Service Bulletin

Bulletin No. 2007-08

Dressed Powerheads (3.0 Liter OptiMax)

Air pressure regulator location on port fuel air

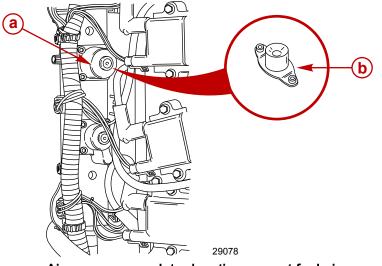
The original 2001 and 2002 dressed powerheads used a one piece air regulator on the port fuel rail. The 2003 and newer models use a multi-piece regulator.

- a Multi piece air regulator on port fuel rail 2003 and newer
- **b** One piece air regulator on 2001/2002 models

If a multi-piece regulator is found on the port rail, order replacement powerhead parts from the 2003 parts list.
